1.0 Introduction

G-IV s/n 1225, N450KK is currently operated by La Venezolana de Seguros y Vida CA.

G-IV S/N 1225 Structural Evaluation-Over Pressurization Event

Fig. 5-11

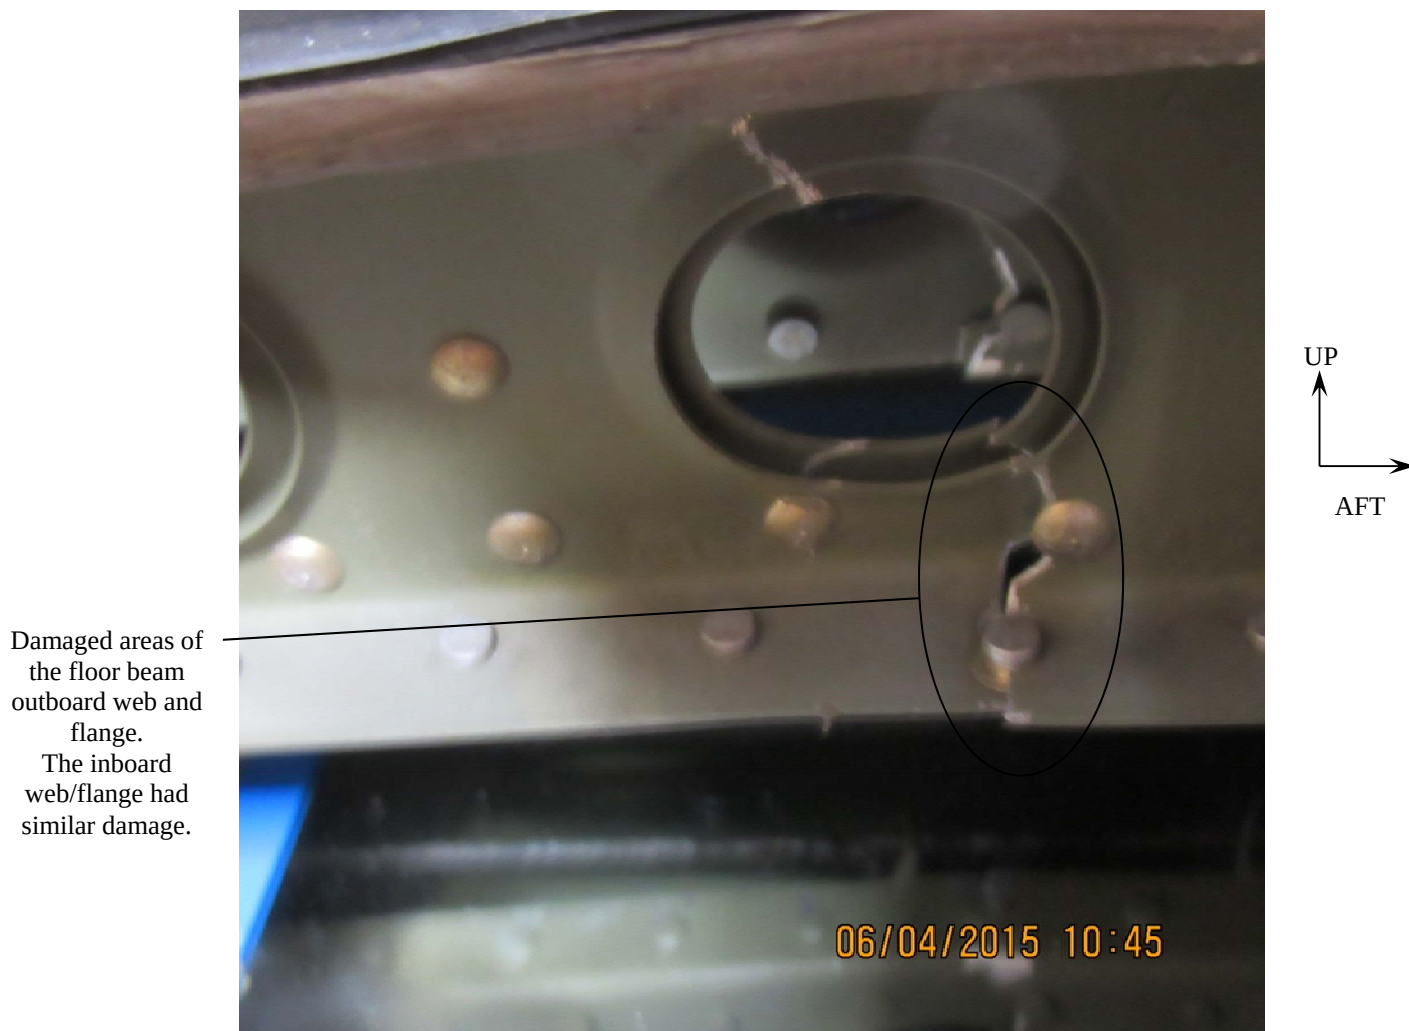
- a. The 1159B21284-43 Beam Installation was cracked and distorted at the following locations:
 - (a) FS 360.00 - (Inboard and Outboard Sides) (Fig. 5-11 and 5-12).
 - (b) FS 373.00 - (Inboard Side) (Fig. 5-13).
 - (c) FS 384.00 - (Inboard and Outboard Side) (Fig. 5-14).
 - (d) FS 412.00 - (Inboard and Outboard Side) (Fig. 5-15).
 - (e) FS 452.50 - The attachment joint had indications of diagonal buckling on the aft 6" of the web on the inboard and outboard side of the beam. (Fig. 5-16).

- iii. Repair/Resolution:
 - a. Remove and replace the 1159B21284-43 Floor Beam to the requirements of the 1159B20005-7 Structure Assy and 1159B20005-5 Structure Instl.
 - b. Document and submit to GAC Technical Operations any structural damage identified with a full description and digital photos for evaluation

Fig. 5-13

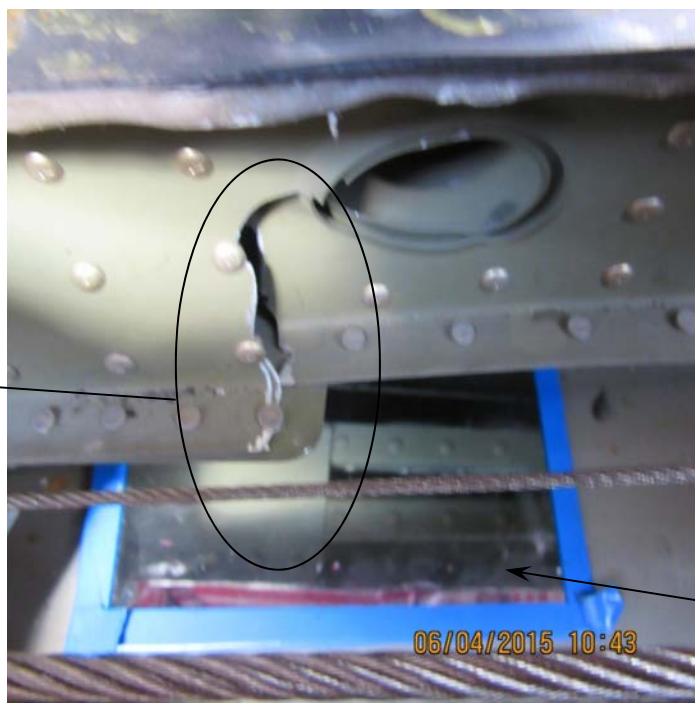
Damaged areas of the floor beam outboard web and flange. The inboard web/flange had similar damage.

Fig. 5-18

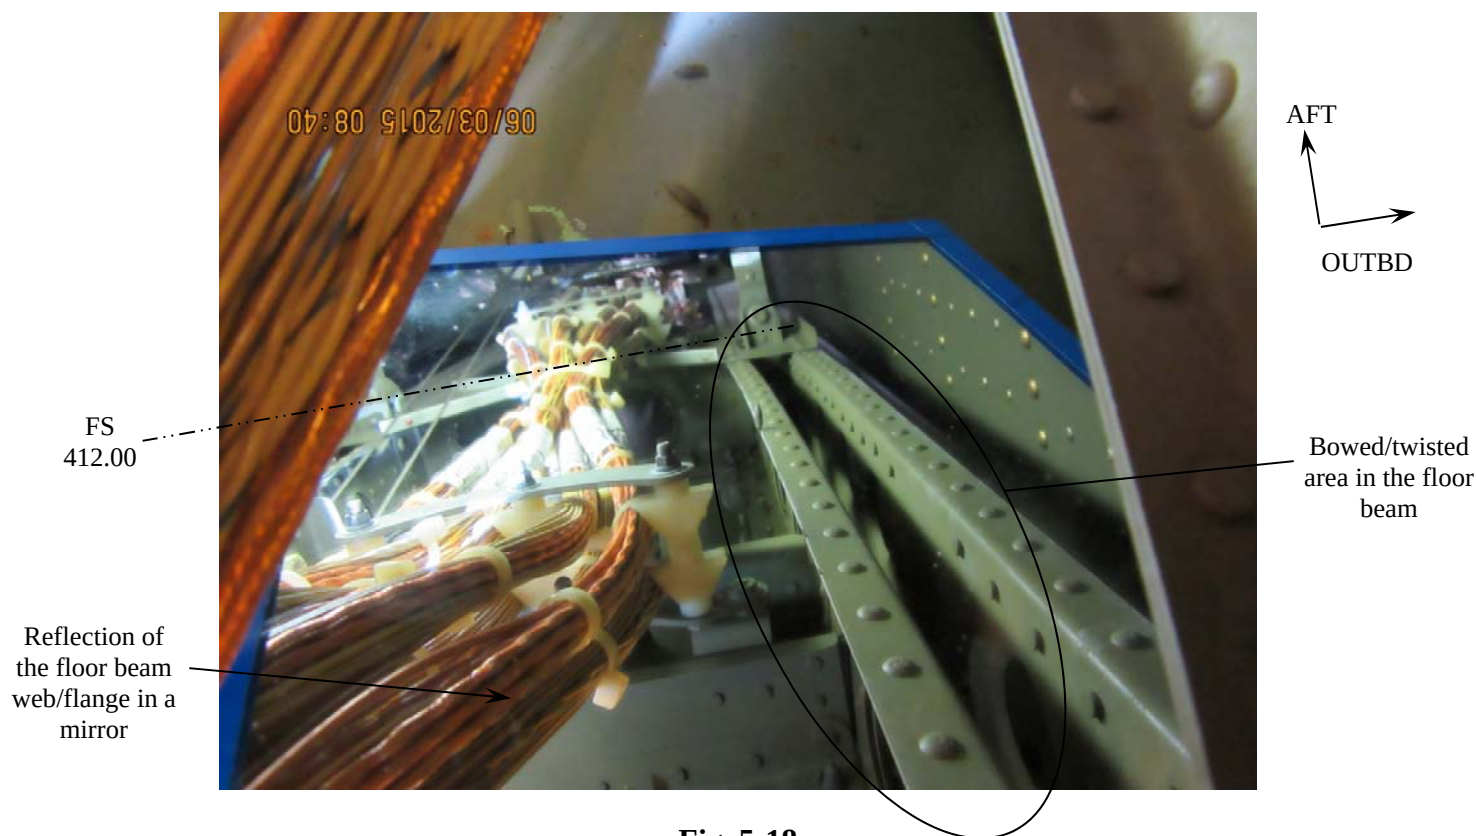
- a. The beam was deflected (twisted) outboard of location between FS 359.00 to FS 384.00 (Fig. 5-18).
- b. The inboard flange of the web was buckled forward of the FS 412 wing link (Fig. 5-19).

- (a) Remove and replace the 1159B21284-45 Floor Beam to the requirements of the 1159B20005-7 Structure Assy and 1159B20005-5 Structure Instl.
- (b) Document and submit to GAC Technical Operations any structural damage identified with a full description and digital photos for evaluation

Fig. 5-20

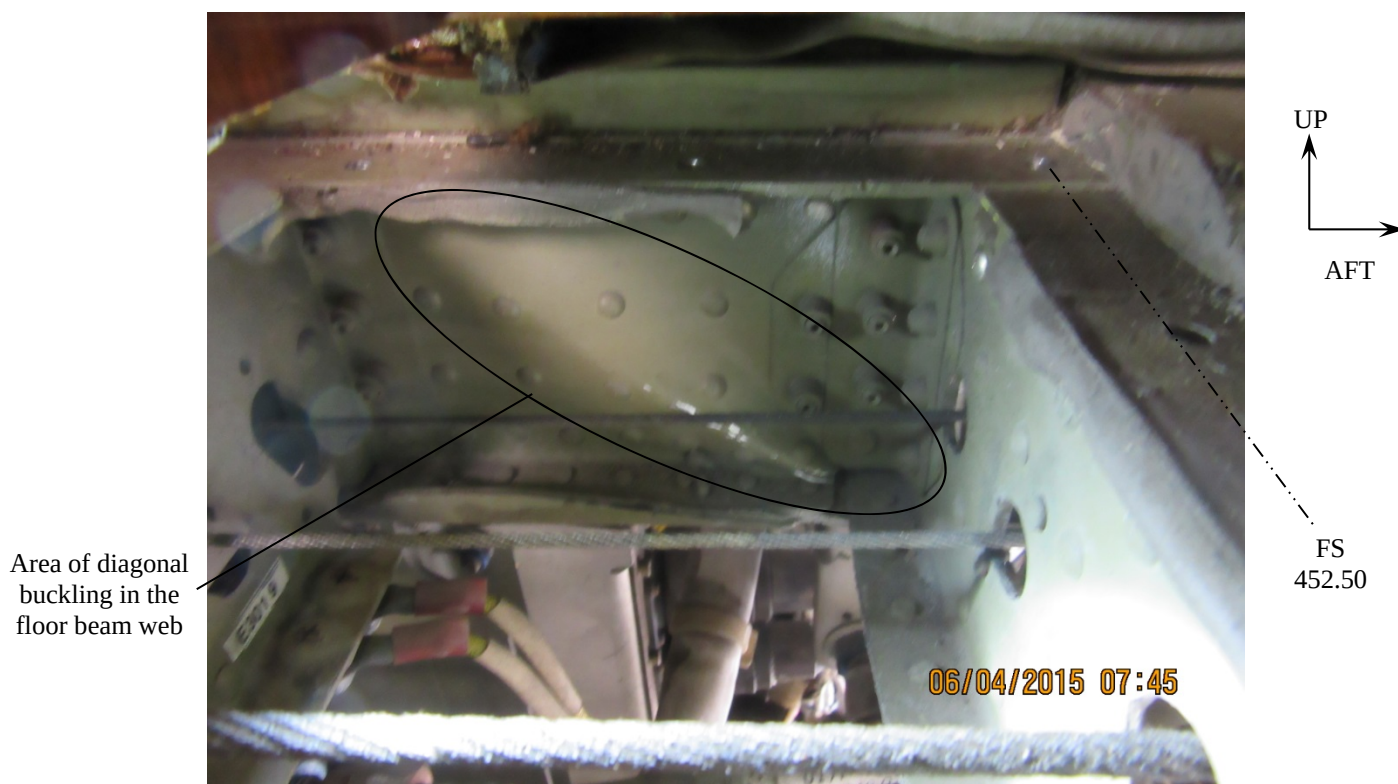
- a. FS 452.50-- The attachment joint had indications of diagonal buckling on the aft 6" of the web on the inboard and outboard side of the beam.

- a. Remove and replace the 1159B21284-44 Floor Beam to the requirements of the 1159B20005-7 Structure Assy and 1159B20005-5 Structure Instl.
- b. Document and submit to GAC Technical Operations any structural damage identified with a full description and digital photos for evaluation

Fig. 6-2
View looking inboard at the LH Skin

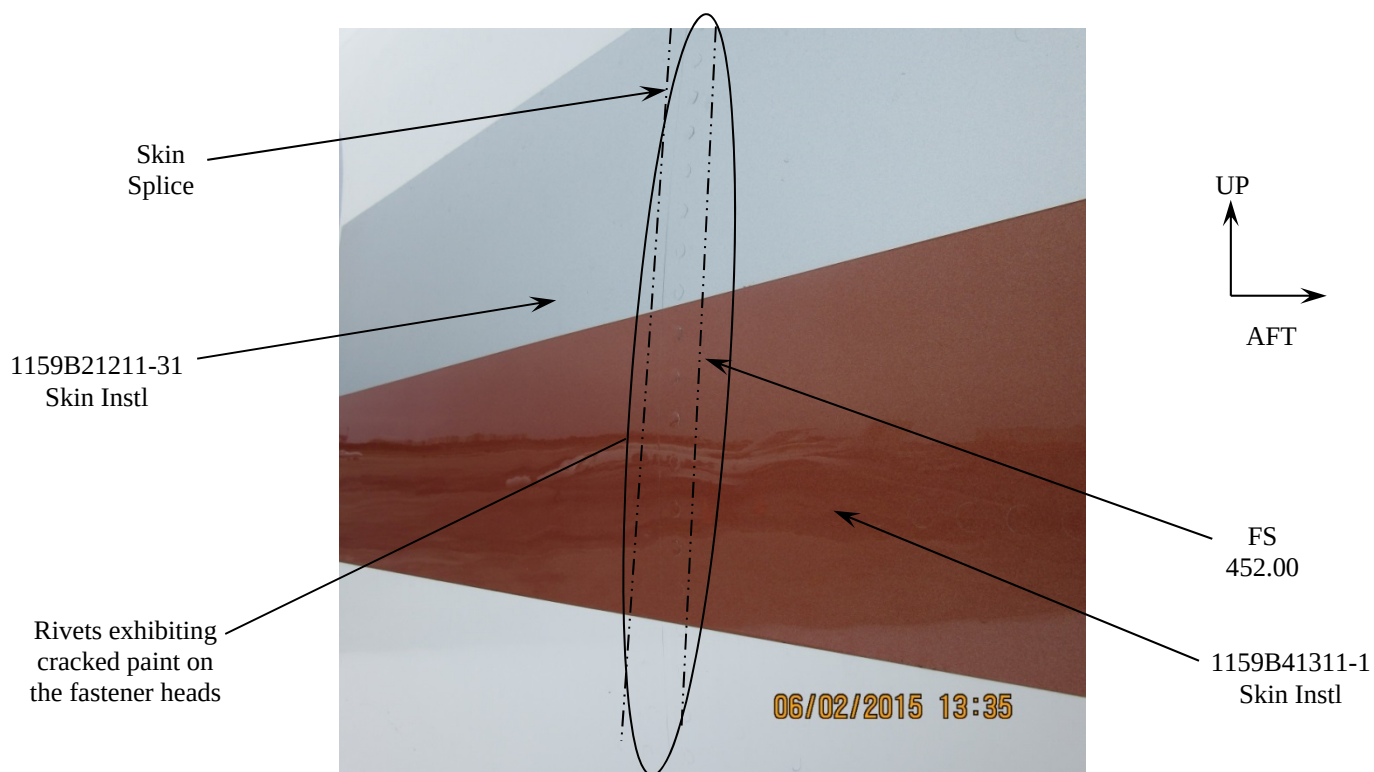
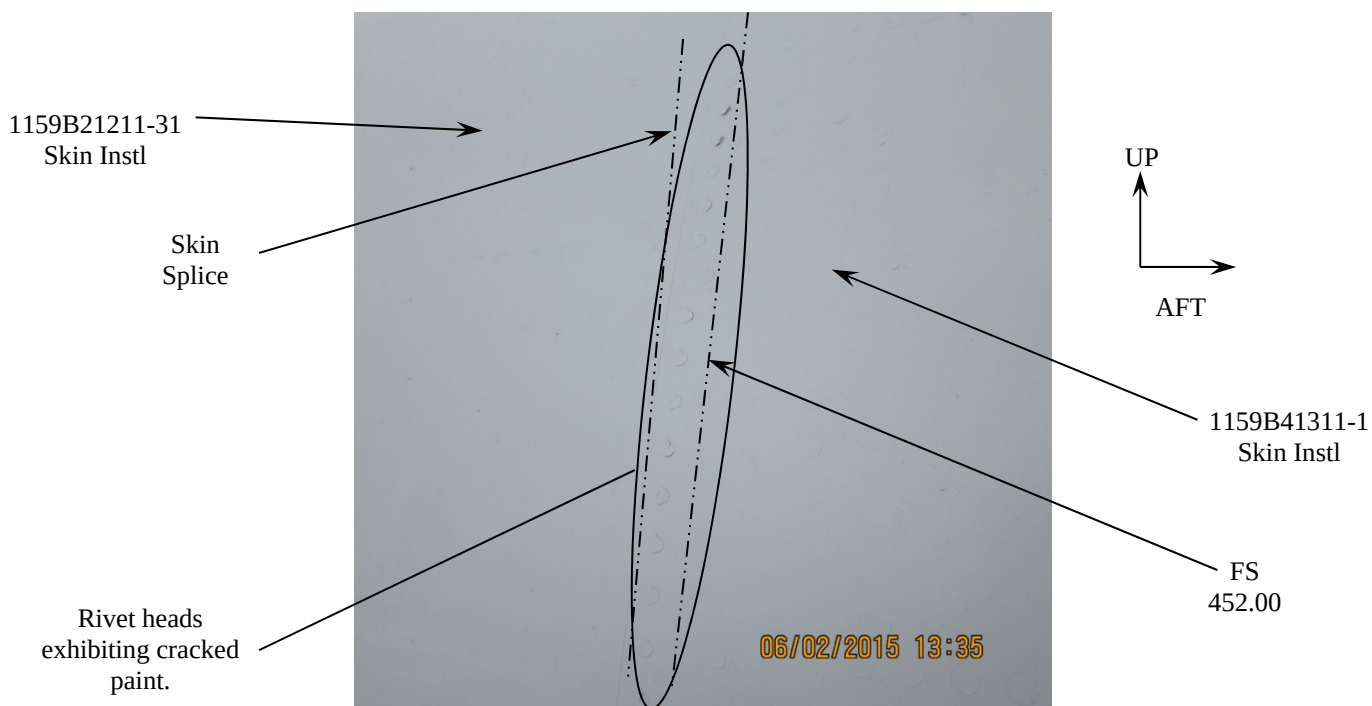
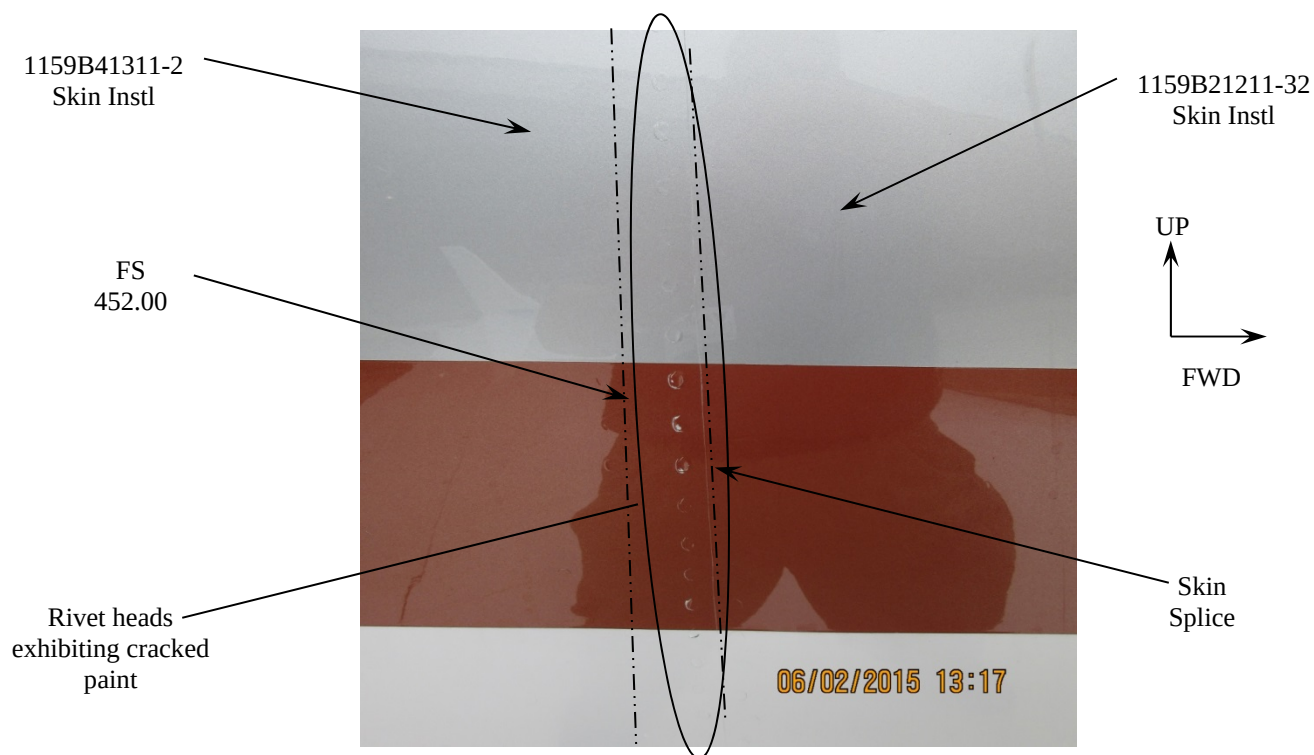
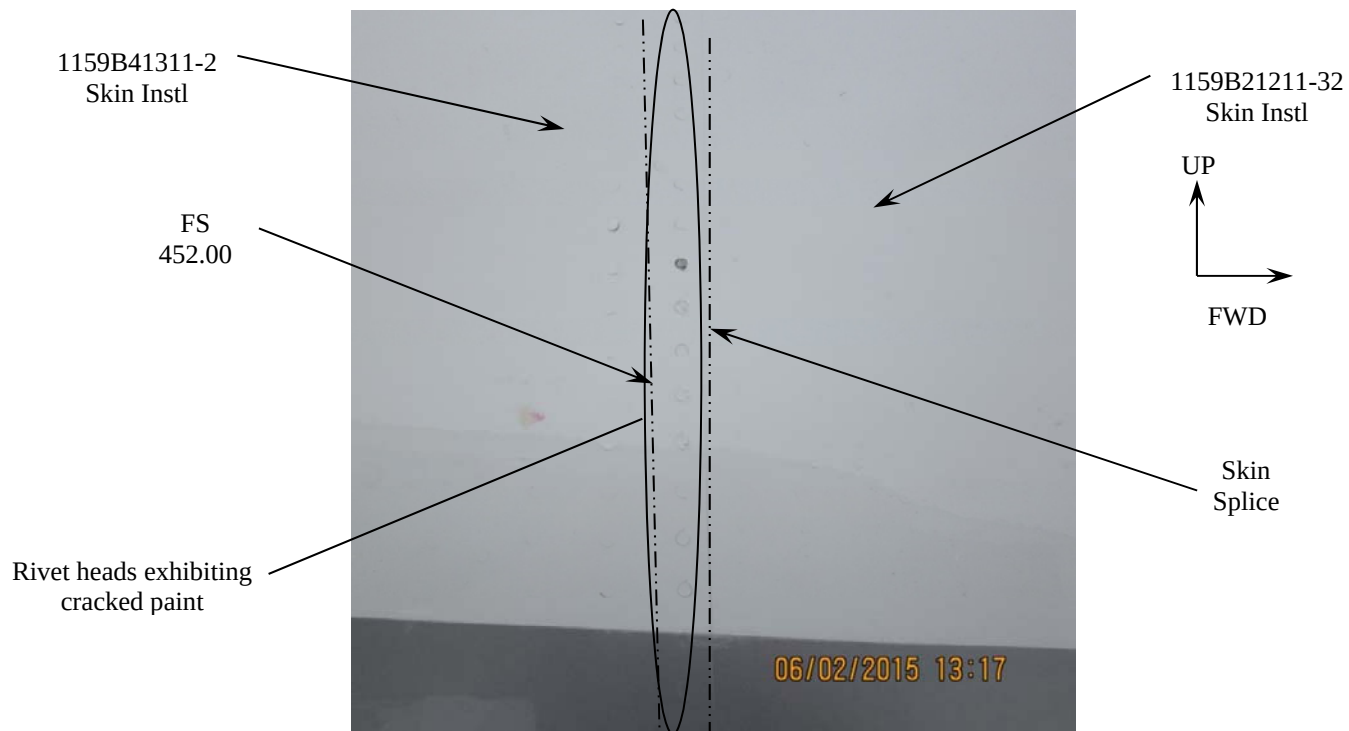
- The interface between the 1159B21281-41 Beam Assy and the 1159BH21011-29 Panel Assy exhibited an area of separation between the matting surfaces.
- See Section 5.0 for the floor beam findings at FS 452.50
- On both the LH and RH side of the aircraft, between Stringer #9 and the top edge of the wing to body fairing, the forward row of rivets attaching the 1159B41311 Skin exhibited evidence of cracked/lifting paint on the rivet heads (See Fig.'s 6-2 to 6-5).

- i. Perform a complete visual inspection of the 1159B21281-1 Beam Instl. At FS 452.50.
- ii. Perform the Pressure Differential Exceedance Inspection in Accordance with the G_IV MSG-3 MM, Section 05-50-00, Section 13.
- iii. Document and submit to GAC Technical Operations any structural damage identified with a full description and digital photos for evaluation

Fig. 7-1

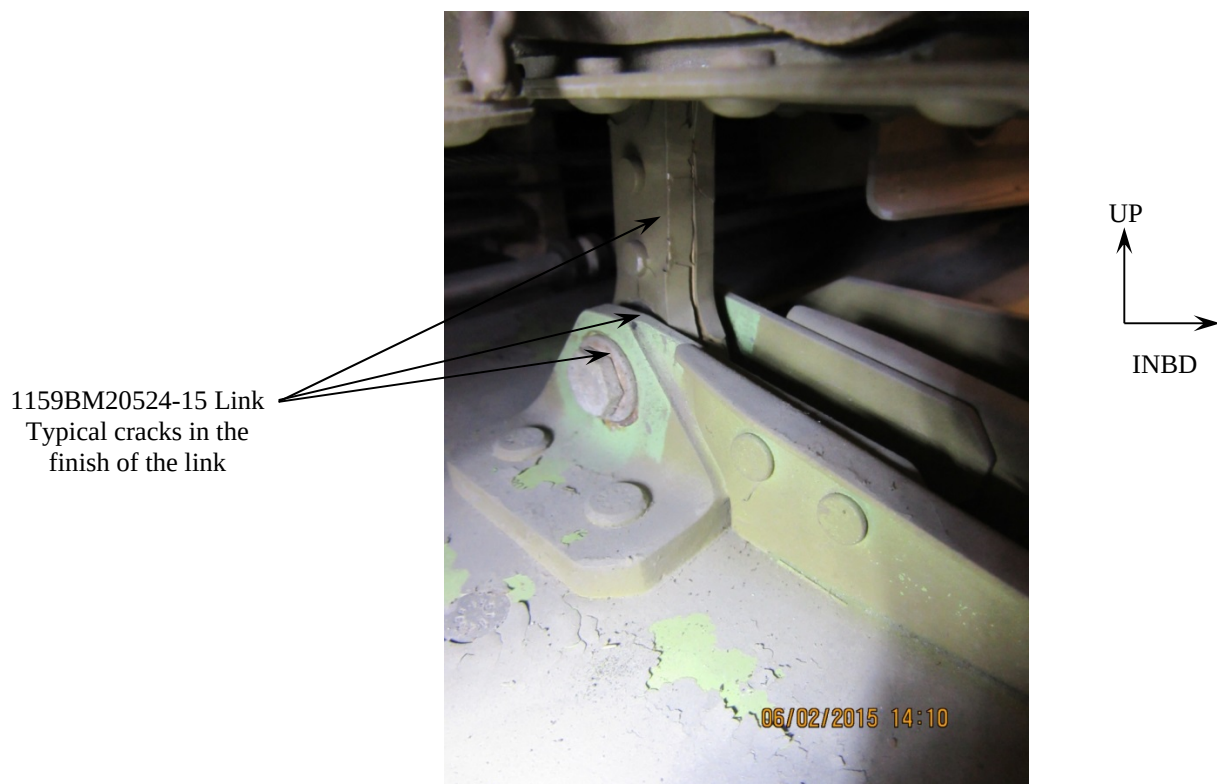
- i. FS 345.875:
 - a. LBL 30.5 No link at this location.
 - b. LBL 18 The link appeared to be vertical and installed properly.
 - c. LBL 6 The link exhibited cracked finish on multiple faces (Fig. 7-1).

FS 345/LBL 6.0 Wing link exhibiting cracked finish on multiple surfaces

- i. At each identified link location, remove and replace the noted link(s) and install with new hardware in accordance with Chapter 53-30-00 of the G-IV Illustrated Parts Catalog (IPC):
- ii. Prior to installation of the new links, High frequency Eddy Current (HFEC) Inspect the associated attach fittings on the wings for cracks in accordance with the G-IV Non-Destructive Testing (NDT) Manual. Pay particular attention to the lugs, holes and the fillet radii of the vertical legs.
- iii. Inspect the hole diameters of the associated attach fittings on the wings (Ref. Fig. 7-10):

Fig. 7-5

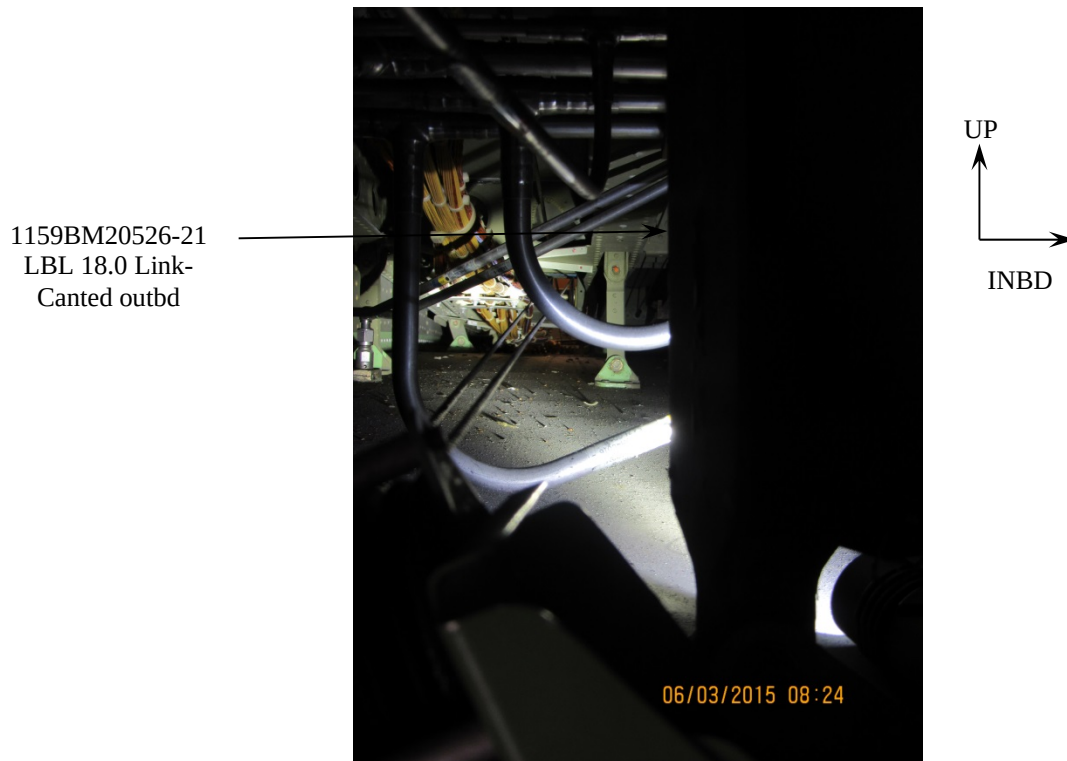
- iii. FS 412.00:
 - a. LBL 30.5 The link was attached at the upper and lower points. The upper attachment was leaning outboard (Fig. 7.6).
 - b. LBL 18 The link was attached at the upper and lower points. The upper attachment was leaning outboard (Fig. 7-5).
